To: Plan Holders for Improvements to the  
Washington County Airport  
Mineral Point, Missouri  
MoDOT Project No. 24-060A-1 & 24-060A-2

Transmitted herewith is **Addendum No. 1** to the Issued for Bid Contract Documents, Specifications and Plans dated May 28, 2024, for Improvements to the Washington County Airport.

**ADDENDUM NO. 1  
TO  
CONTRACT DOCUMENTS, SPECIFICATIONS AND PLANS  
FOR IMPROVEMENTS TO THE  
WASHINGTON COUNTY AIRPORT  
MINERAL POINT, MISSOURI  
MODOT PROJECT NO. 24-060A-1 & 24-060A-2**

UNDERDRAIN PLAN STA. 8+50 TO 12+50 RUNWAY 2/20		SHEET NAME C512
MoDOT PROJ. NO. 24-060A-1 & 24-060A-2	WOOLPERT PROJ. NO. 1015274

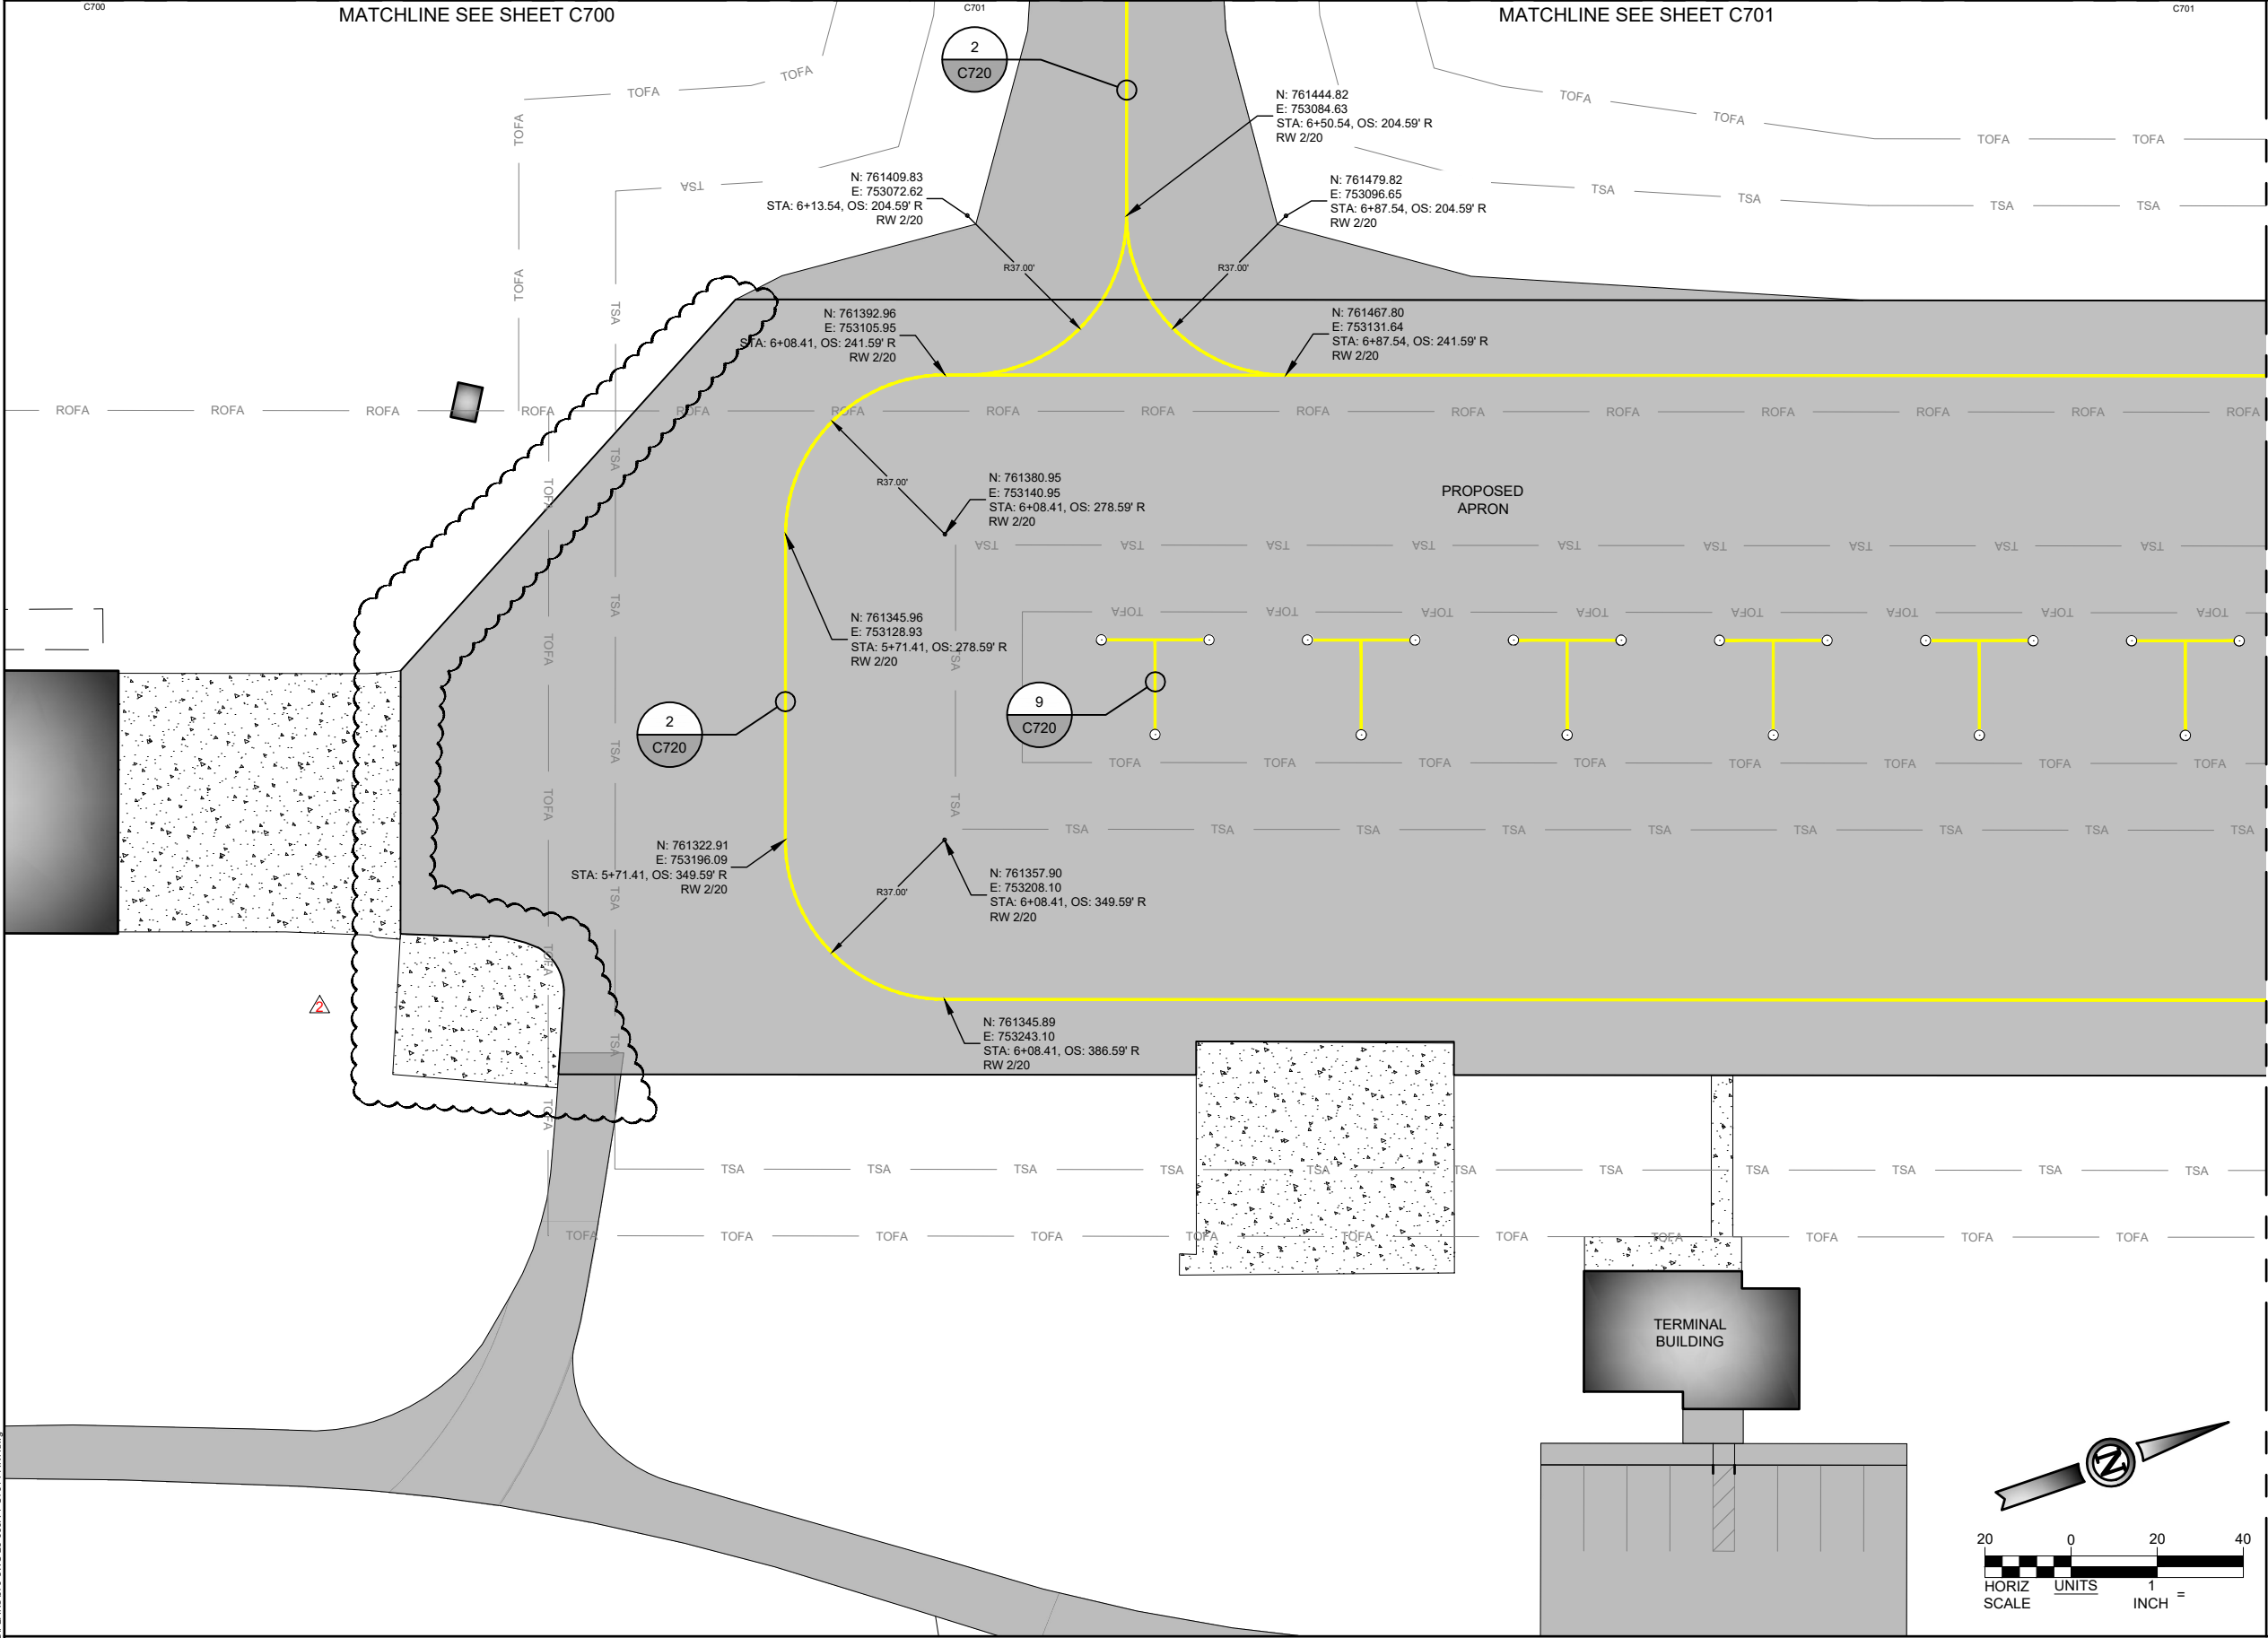
**Justification:** Updated the underdrain plan to add underdrain pipe and structures along the east edge and north edge of the apron.

PAVEMENT MARKING PLAN		SHEET NAME
STA. 4+00 TO 9+25		C711
RUNWAY 2/20		SHEET NO.
MoDOT PROJ. NO. 24-060A-1 & 24-060A-2		108 of 145
WOOLPERT PROJ. NO. 1015274

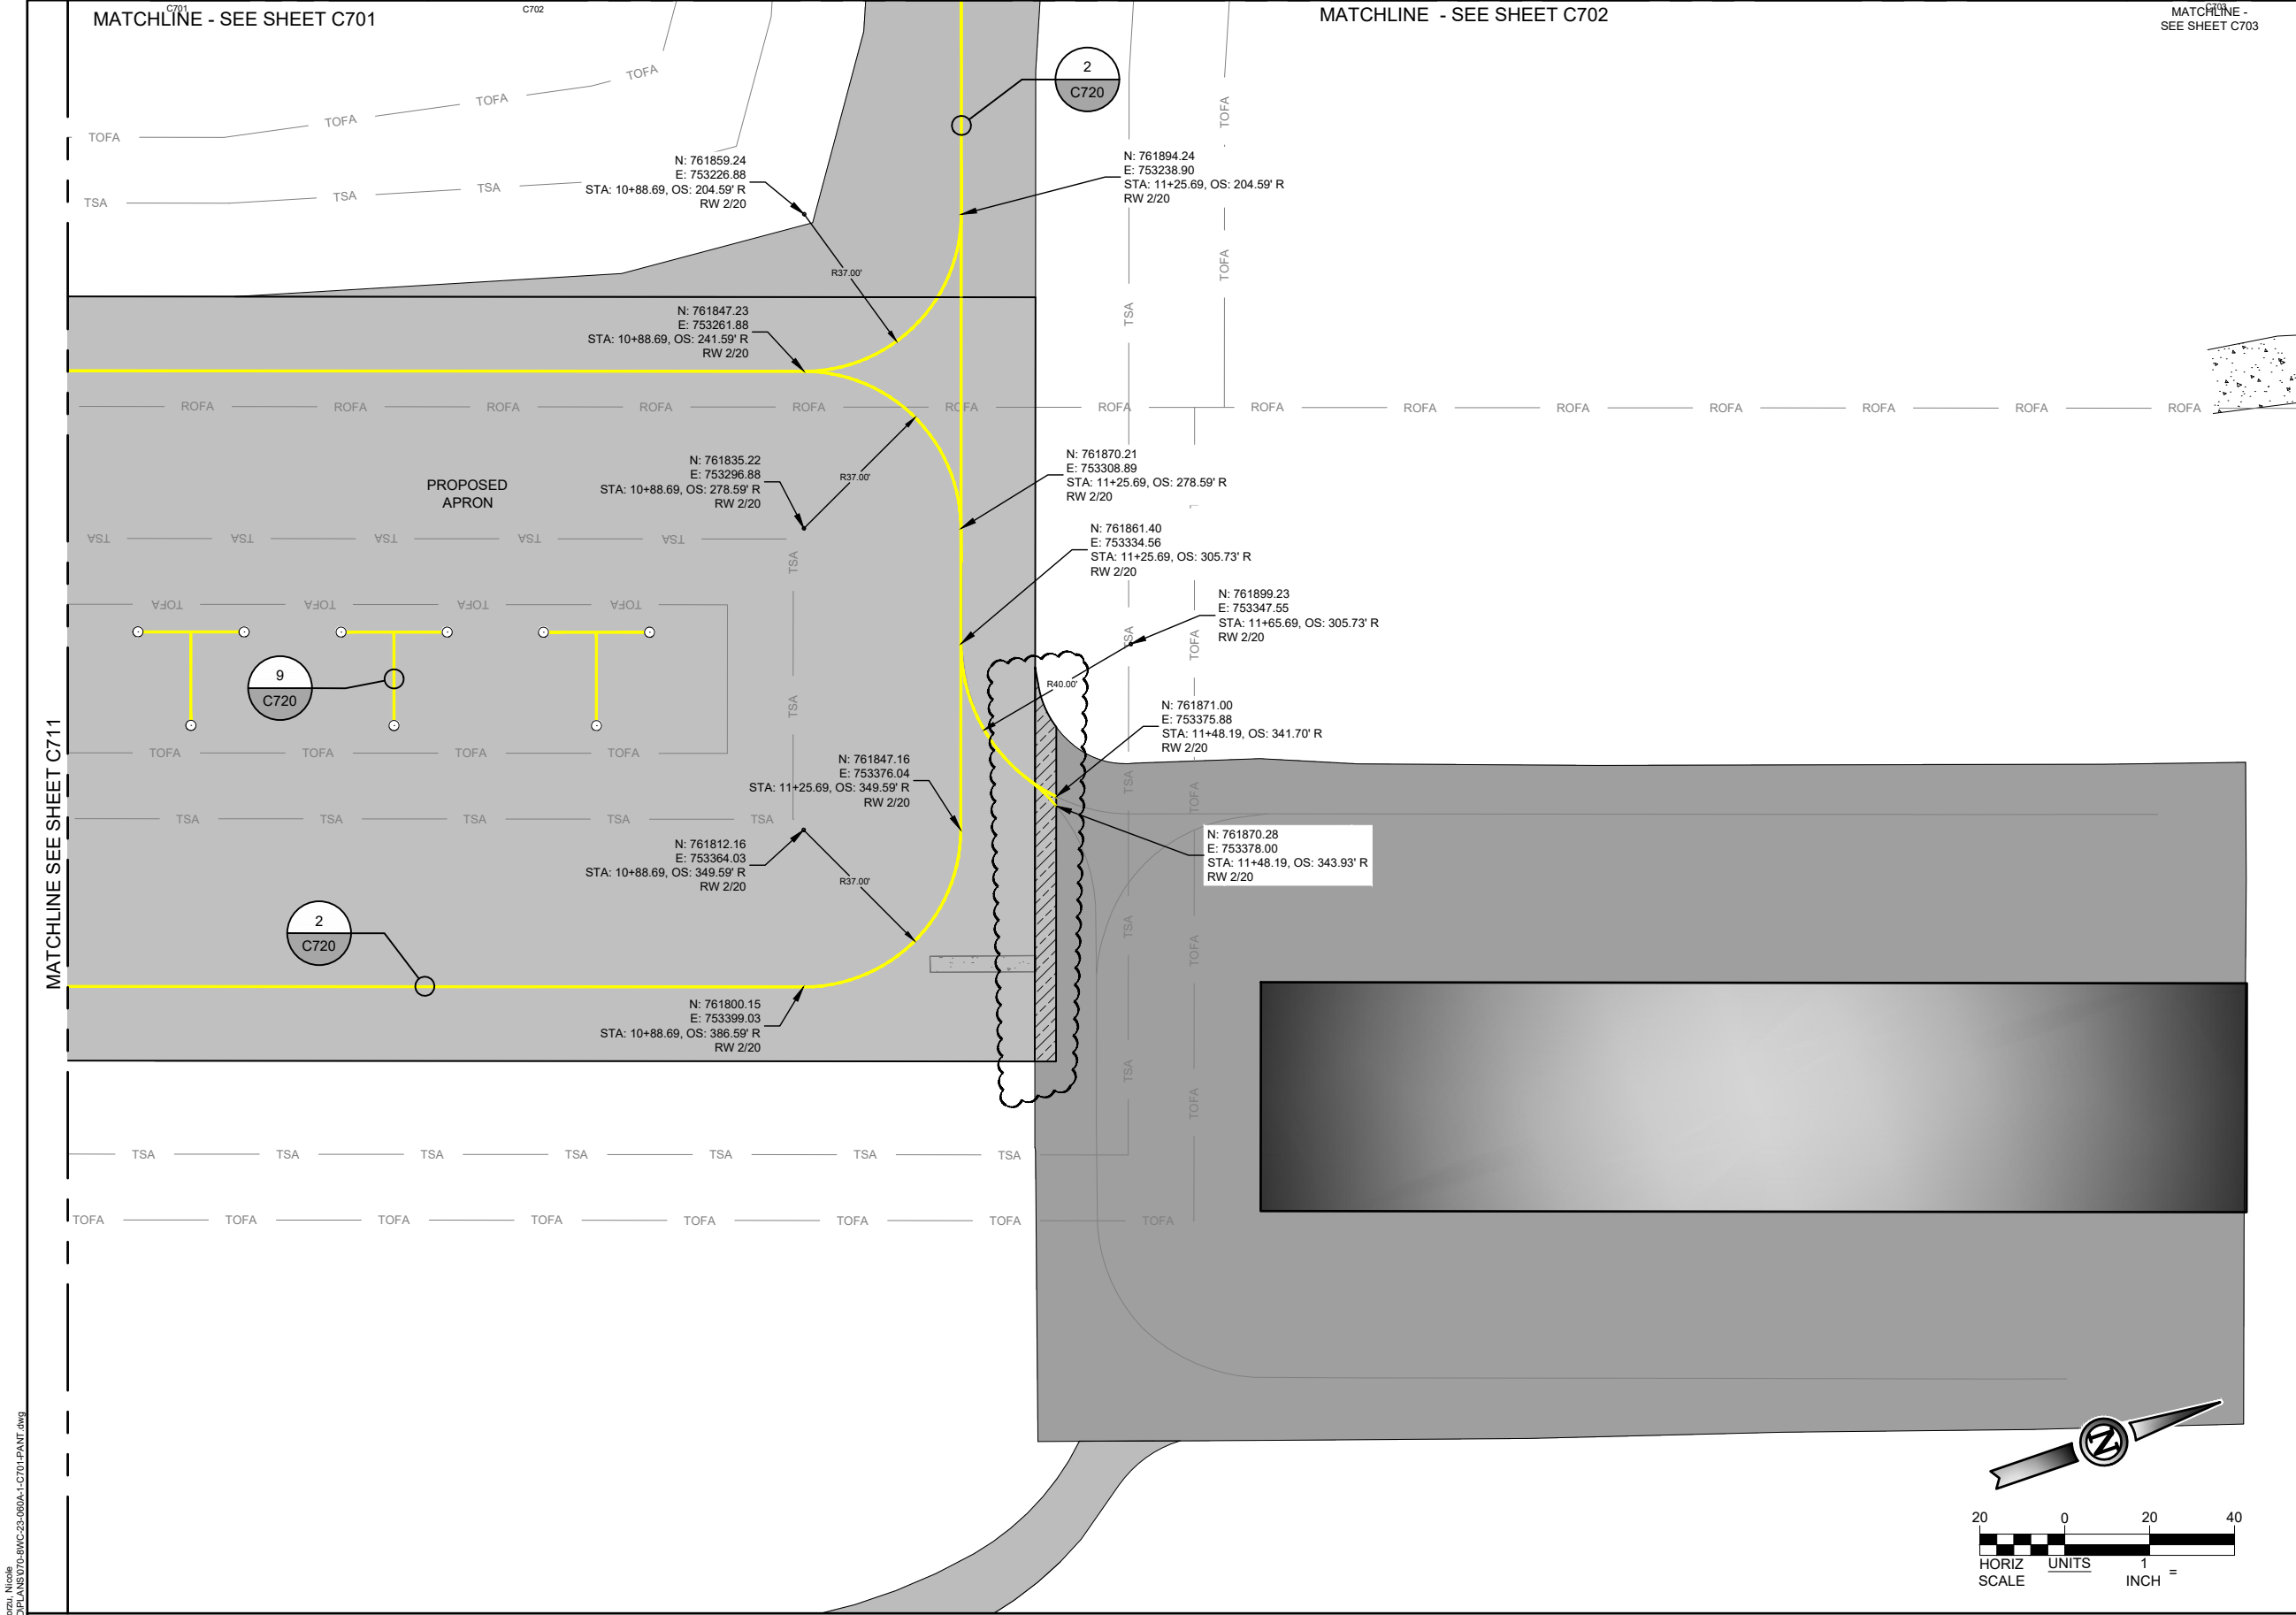
**C711 - (109 of 145) Pavement Marking Plan, Sta. 4+00 to 9+25, Runway 2/20**

SHEET NAME	
C808	
SHEET NO.	
120 of 145

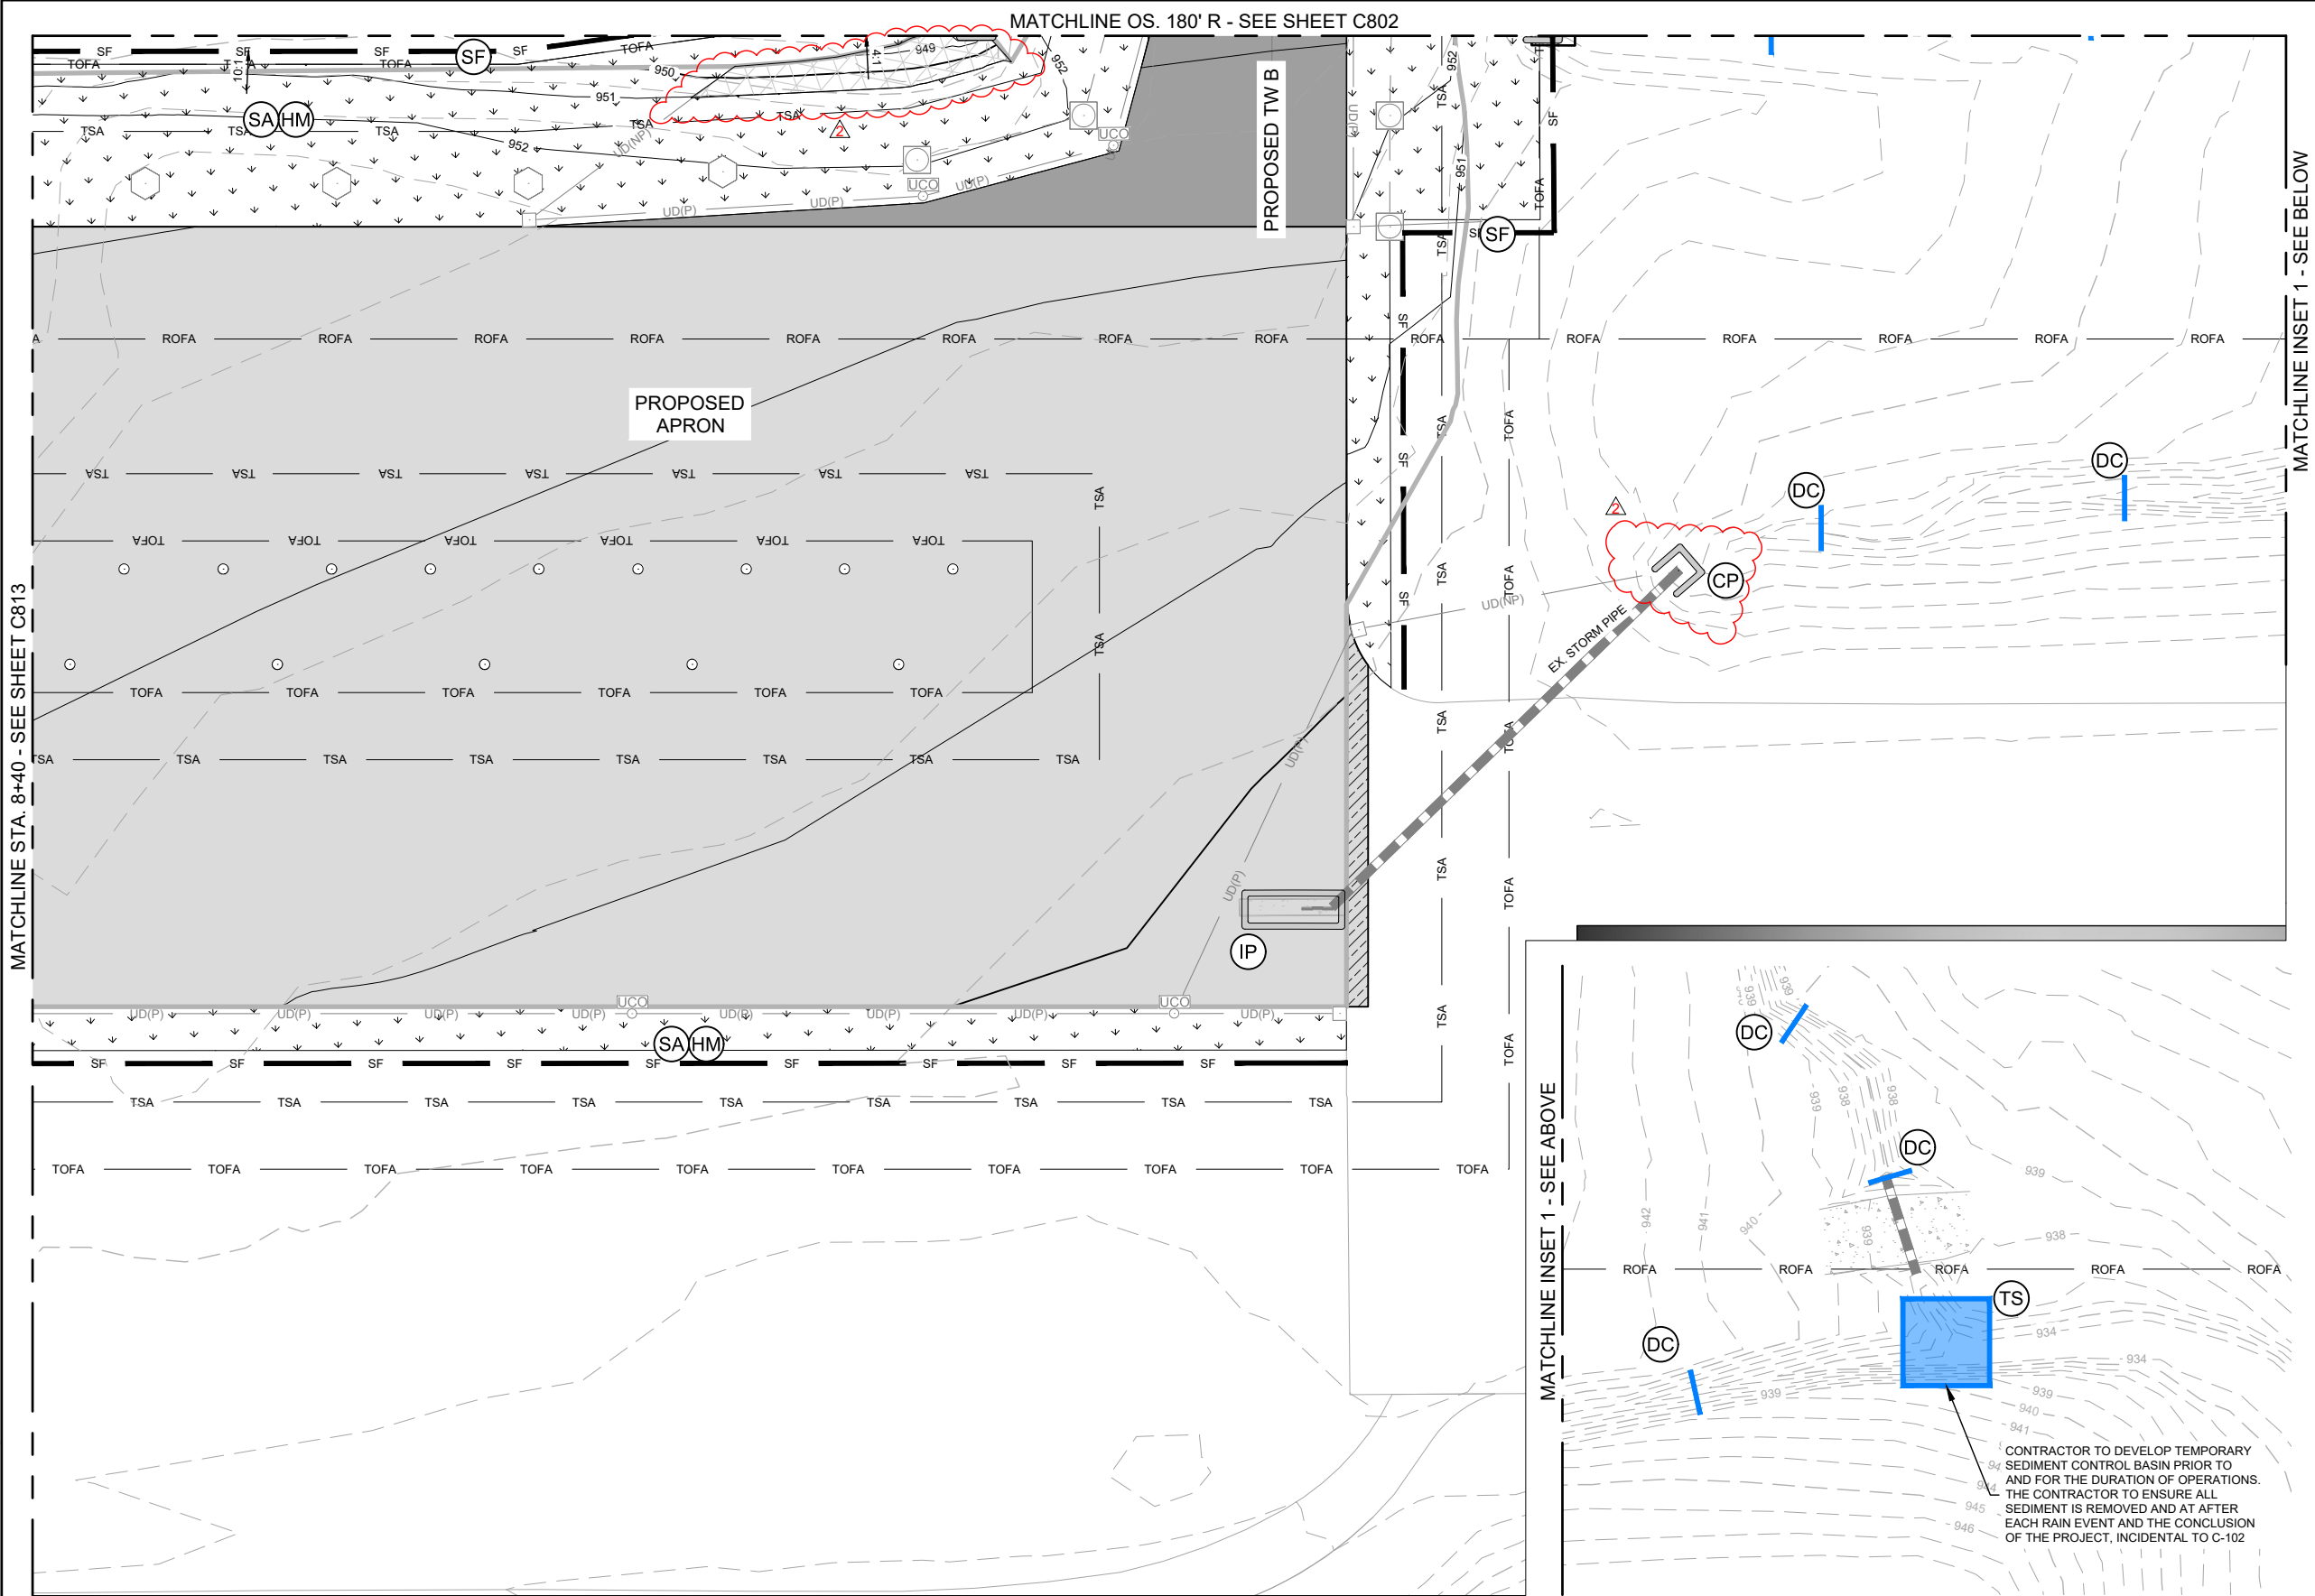
**C808 - (120 of 145) Erosion Control Plan, STA. 39+60 to 44+80, Runway 2/20**
